HISTORIC PRESERVATION BOARD

HISTORIC PRESERVATION BOARD MEETING

**PUBLIC HEARING
35 COMMERCIAL STREET**

TO: Chair Pollard and Members of the Historic Preservation Board
FROM: Rob Wiener, Preservation Compliance Coordinator
DATE: December 29, 2020
RE: January 6, 2021 **Public Hearing** – Exterior Alterations and Additions

3 | VIEW OF NORTH SIDE FROM FRANKLIN

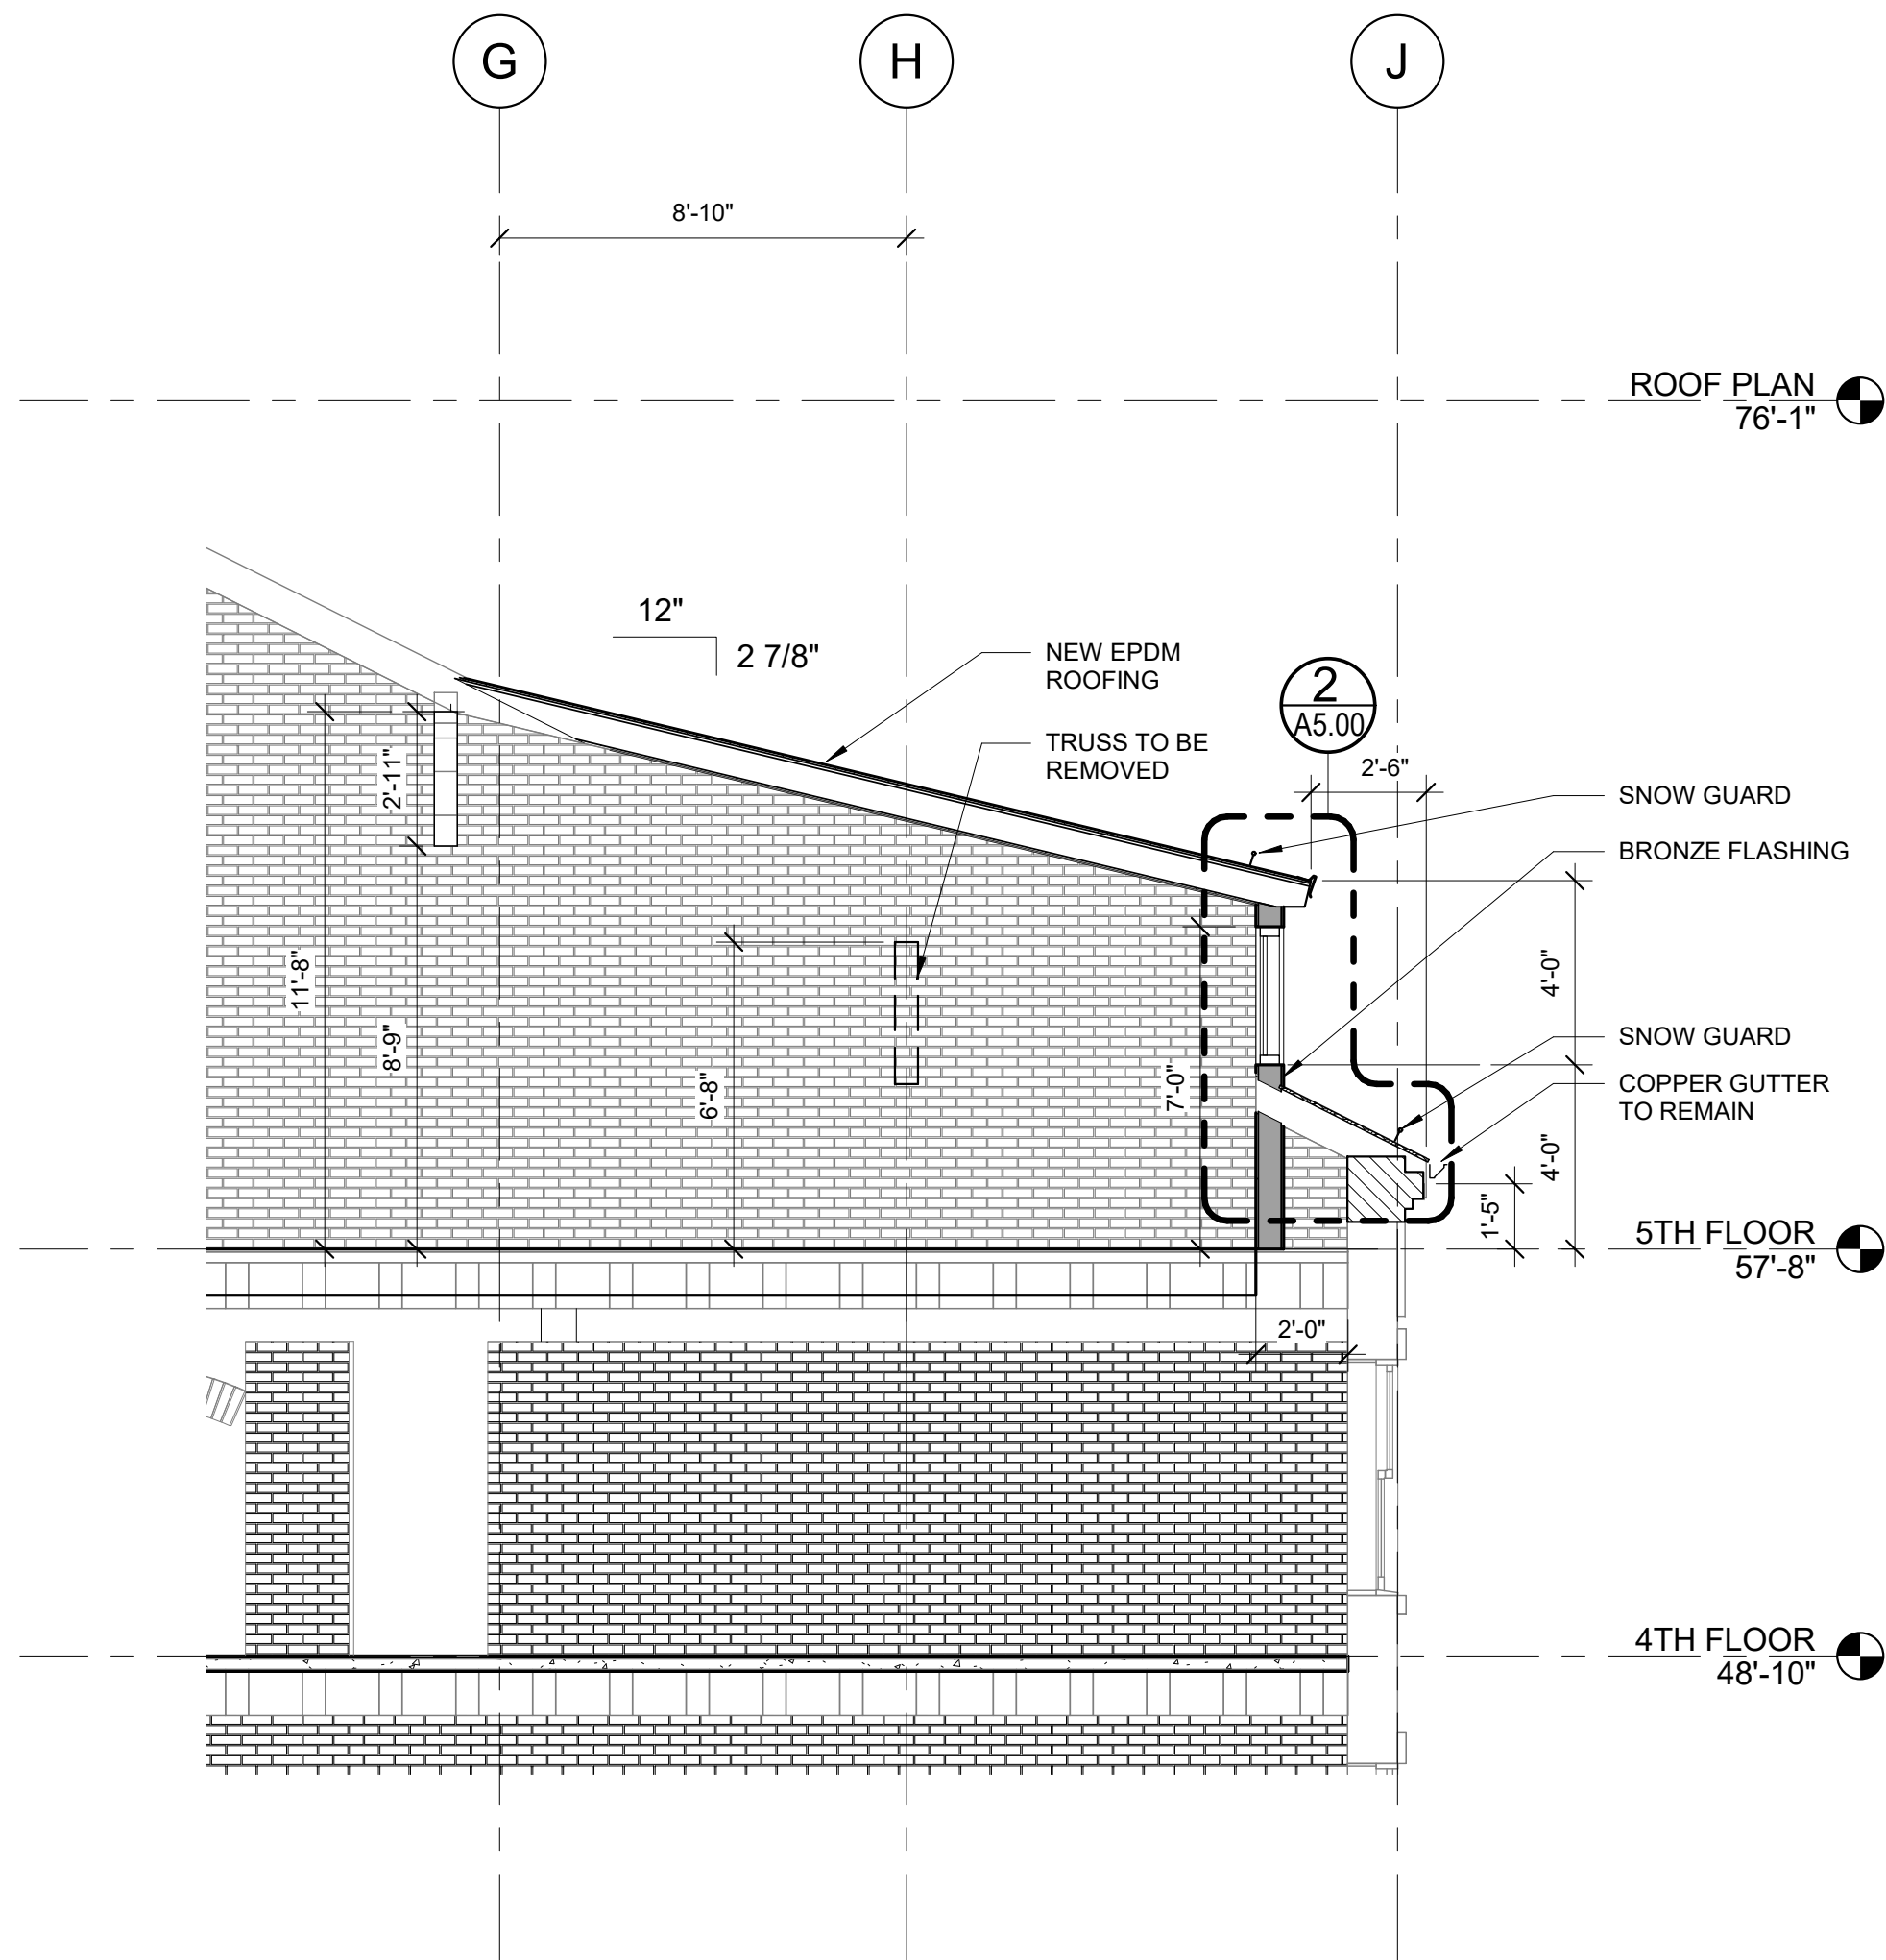
- *Rendering(s) from further up Franklin Street, or from Fore or Middle Street*
 - *Ground floor wood storefront windows*
 - *It was requested that the rear fence meet the northwest corner of the building some distance away from the corner itself.*

- A modified fence layout will allow more of the character of the rear face to be seen.
- In early December, several Board members still questioned the necessity of the inset decks on the north-facing back of the building, and may conclude that the clean simplicity and larger remnants of original roof of the proposed south elevation should be mirrored on the back. Mr. Aftandilian's letter reiterates that the deck features are minimally visible, and they are an important part of the design program and the success of the venture. New renderings depicting the appearance of the north side from some distance up Franklin Street and from Middle Street indicate the inset decks would certainly be visible, but not prominently so because of distance. At this time, the inset decks are perhaps the most substantial unresolved question.

13. Rendering taken from up Franklin street added to demonstrate views of recessed decks , note location was taken be walking up Franklin until roof could be seen. We hope that this rendering will show the recessive nature of the decks in relationship to the overall massing of the building.
